PRODUCT CHANGE NOTIFICATION

#PCN-IF-VY3B-14

Business Unit	Product Line Code	Type of Change	Action	Date of issue
IF	CK6	Aesthetic	Notify Distributors and Field	7/2/2014

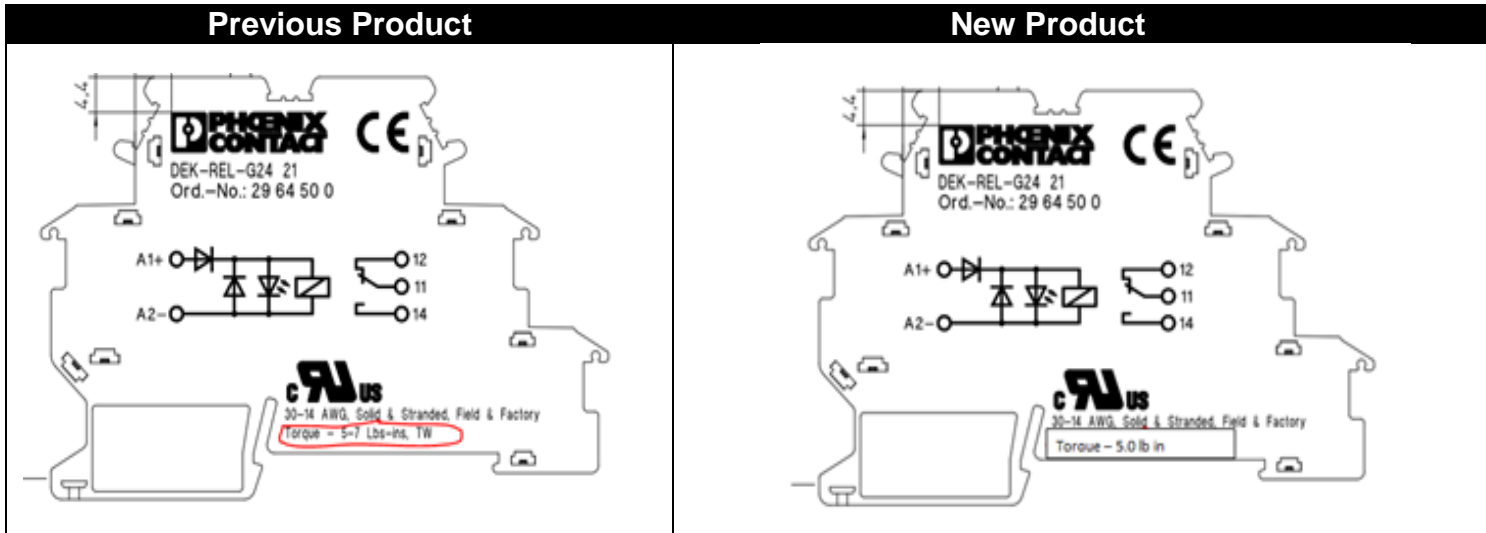
Phoenix Contact has updated the torque value printed on the side of the DEK relays to reflect the correct UL specified torque value, which is 5.0 lb-in. The effected DEK part numbers are listed below.
